From: [Detterman, Karel, Env. Health](#)
To: ["Robert Kitay"](#)
Cc: [Roe, Dilan, Env. Health](#); [Mark Elliott](#); [JD SERVICES Debris Box](#); [Dave Allen](#)
Subject: RE: Fuel leak Case RO3159 and GeoTracker Global ID Number T10000006491 - Roofing Facility, 745 Kevin Court, Oakland, CA 94621 RE: 745 Kevin Court, Oakland Work Plan
Date: Friday, December 30, 2016 6:12:01 PM
Attachments: [Attachment 1 and ftpUploadInstructions 2016-12-15.pdf](#)

Thank you for submitting the Revised Figures for the December 29, 2016 Work Plan (Work Plan). Please note that collection and analysis of soil samples from the capillary fringe and the bottom of the boring are consistent with previously approved site soil sampling protocol. Additionally, analysis of saturated soil samples in borings where there are no field indications of soil contamination will facilitate addressing Technical Comment 1 by defining the lateral and vertical extent of residual source. We reviewed the boring log for BH-D yesterday during our meeting, and noted that while there were no field indications (elevated PID readings or soil observations) of impacted soil noted on the boring log, the soil sample collected from 3.5 f

AQUA SCIENCE ENGINEERS, INC. | FIGURE 1

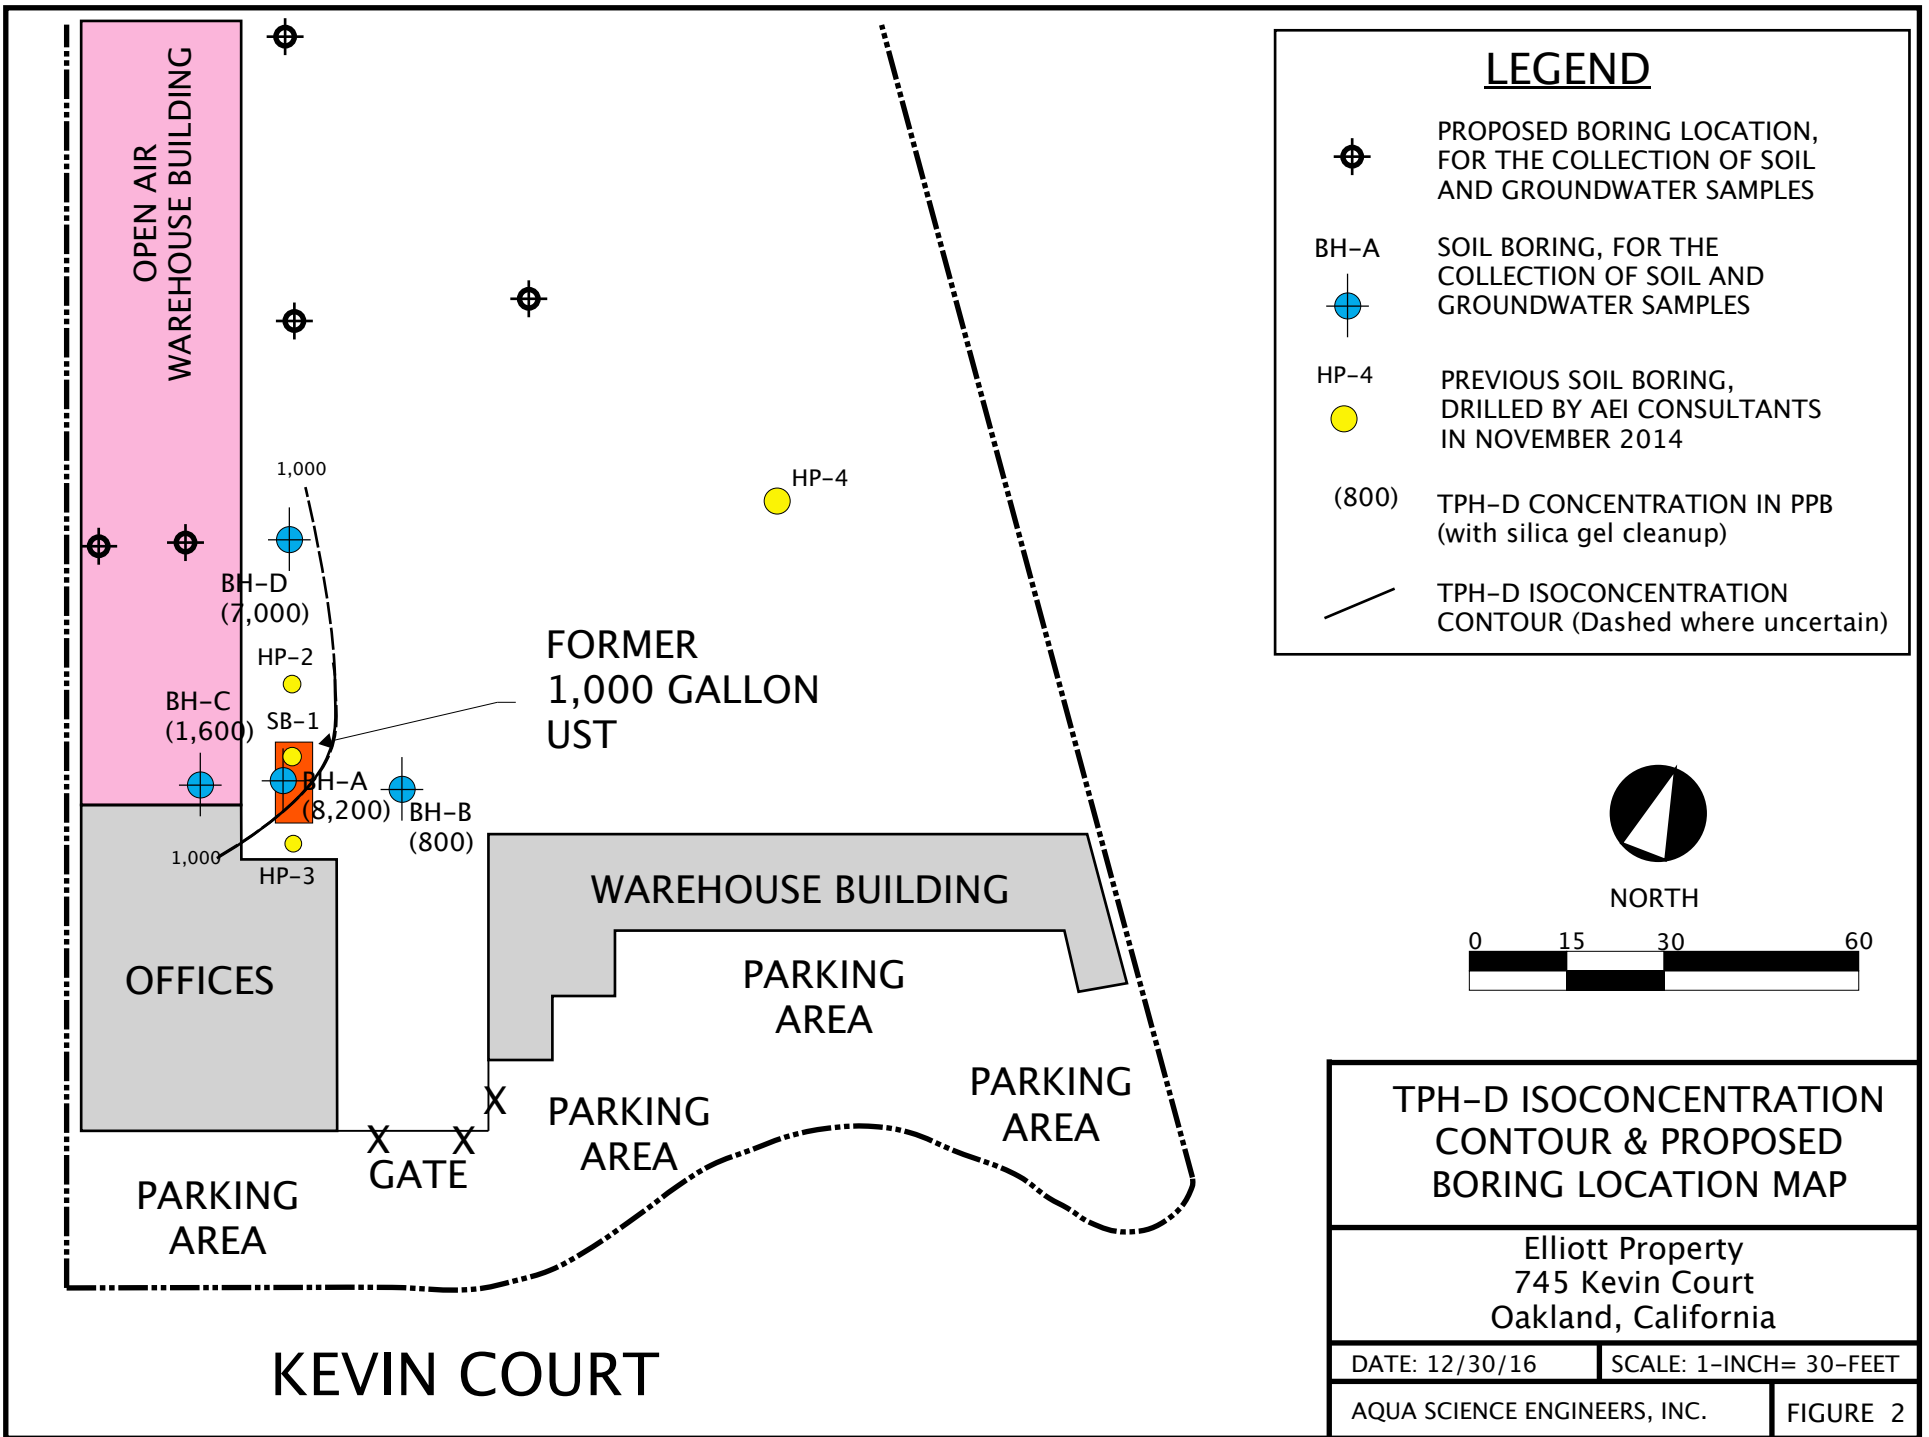
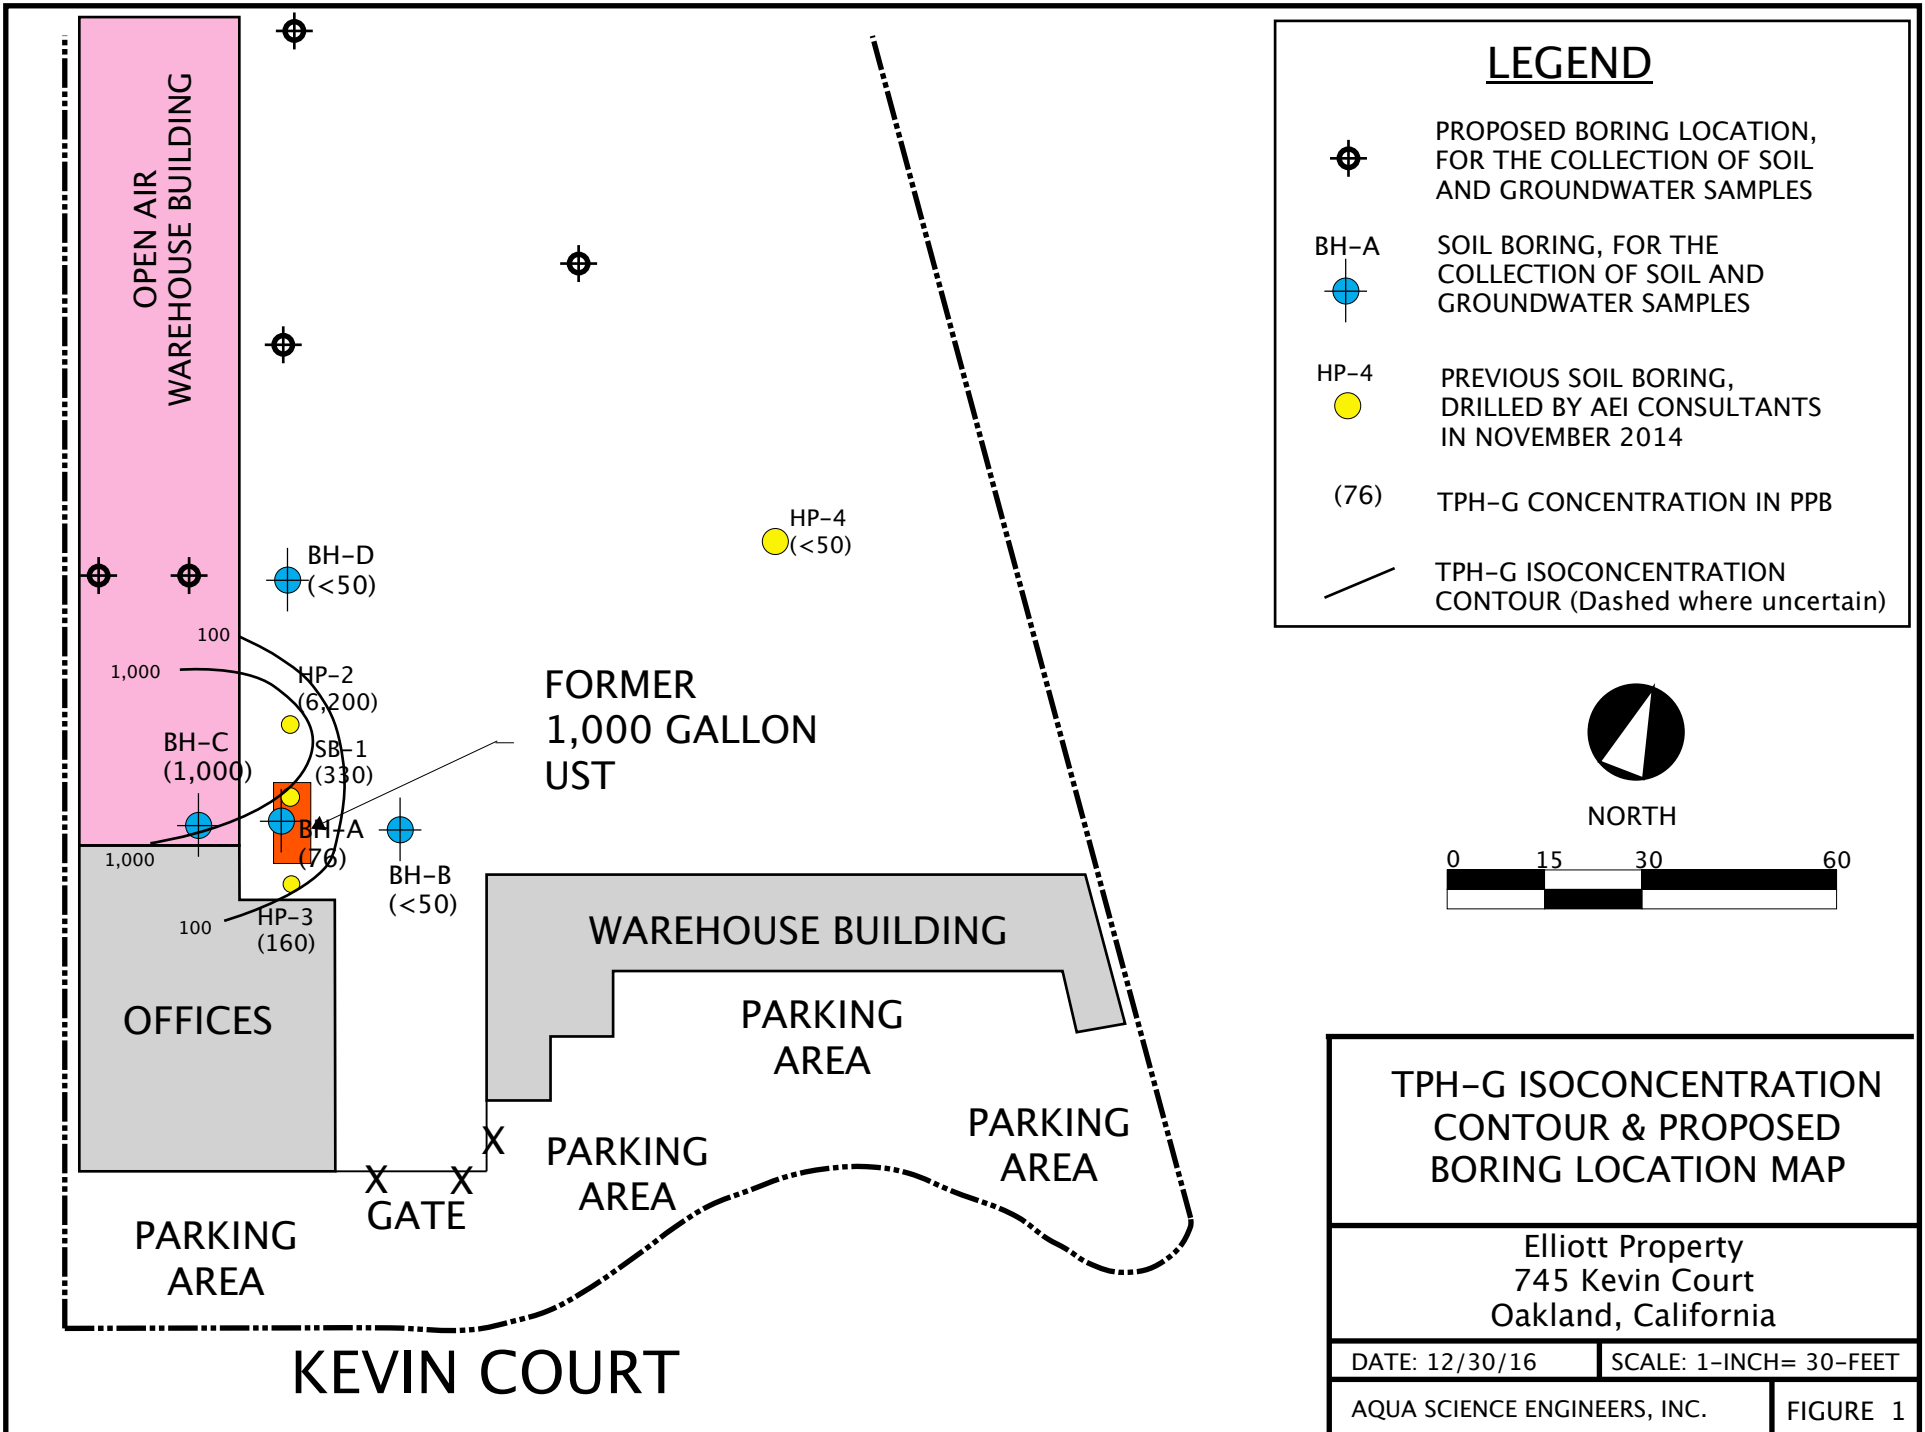
1. As discussed during the meeting and as requested in Technical Comment 1a of ACDEH's December 29, 2016 Directive Letter, please revise the Work Plan's Figure 1 to include Total Petroleum Hydrocarbons as gasoline (TPHg) and TPH diesel (TPHd) groundwater isoconcentrations on revised Figure 1, using dashed lines where data gaps exist.
2. On the revised Figure 1, please also include an adequate number of soil borings in the vicinity of boring BH-D to delineate the lateral extent of TPHd and TPHg between boring BH-D and the property lines to the west, north, and east of BH-D.

Attached are the revised maps you requested. Per your directive letter which crossed in the mail with my workplan, ASE will analyze the additional soil samples as you requested. However, although ASE will comply with the request, ASE does not think that analyzing saturated soil samples in borings where there is no field indications of soil contamination will yield enough useful data to justify the additional cost.
